**TECHNICAL MEMORANDUM NO. 1
SUPPLEMENTAL BASIS OF DESIGN - RESPONSE TO ECRB COMMENTS**

SUBJECT: Terminal 1, Latitude Project – Response to ECRB Comments

Reference: ENGEO; Existing Geotechnical Conditions and Seismic Slope Stability, Terminal One, Richmond, California; July 24, 2017; Project No. 5931.000.000

Project			Terminal One - Section 2-2'		
Scale	1:1000	Author	T. Bradford	Project No.	
Date	October 4, 2017	Condition	Wedge-Type Failure

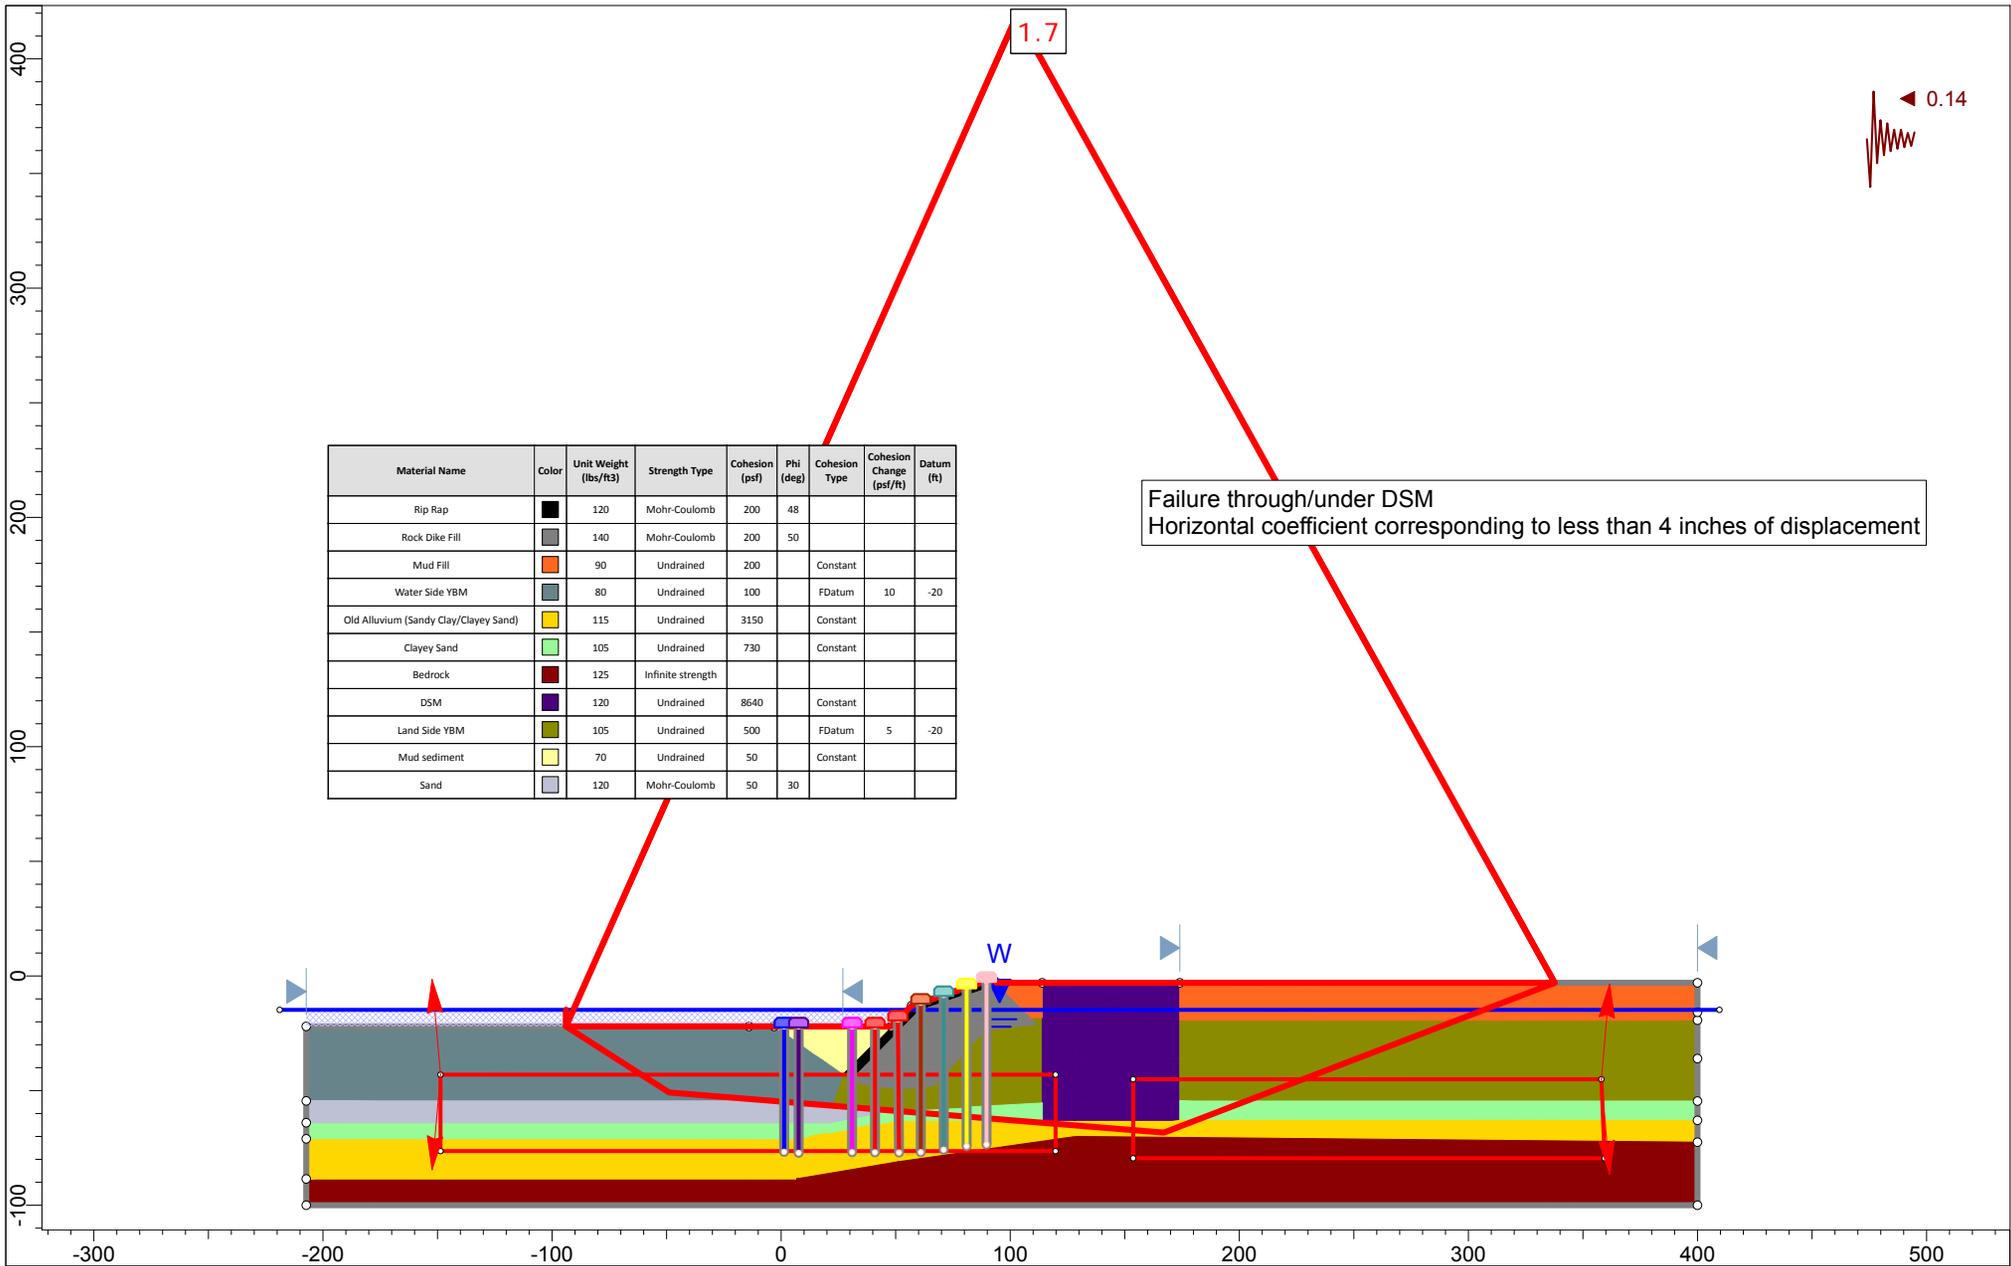
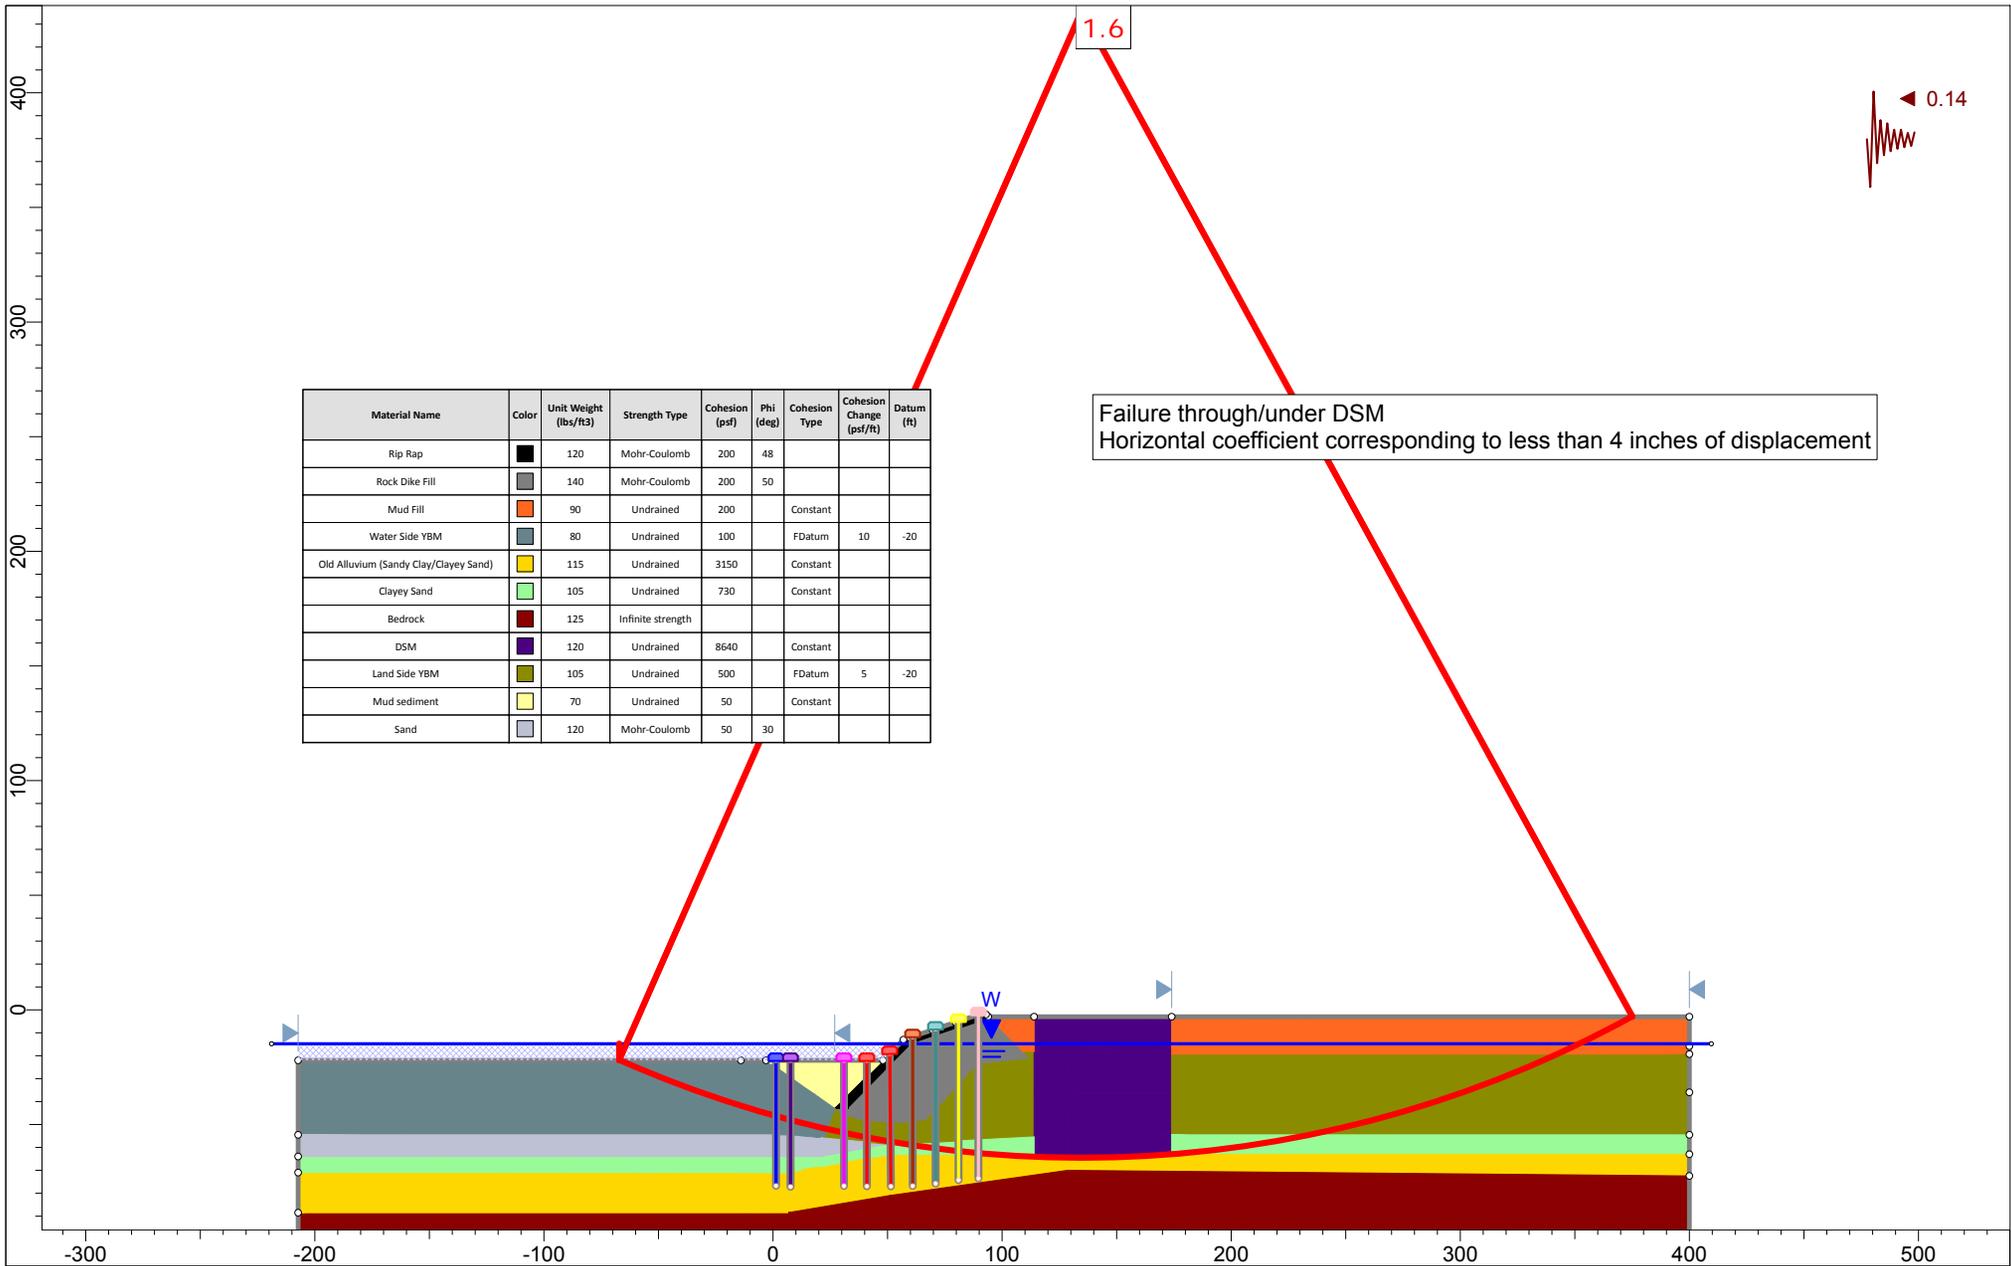
ECRB Comment #3:

Reexamine the deflections for the piles during an event and the configuration and depth of the DSM buttress.

Based on input from the ECRB Board as discussed in our Response #2 above, we revisited and revised our interpreted soil profile for the slope stability analysis of the wharf and shoreline. The presumed potentially liquefiable layer now extends beneath the wharf structure (Figure 3). We present the results of the analysis in Attachment A, which still achieve satisfactory performance based on the analysis criteria outlined in Reference 1.
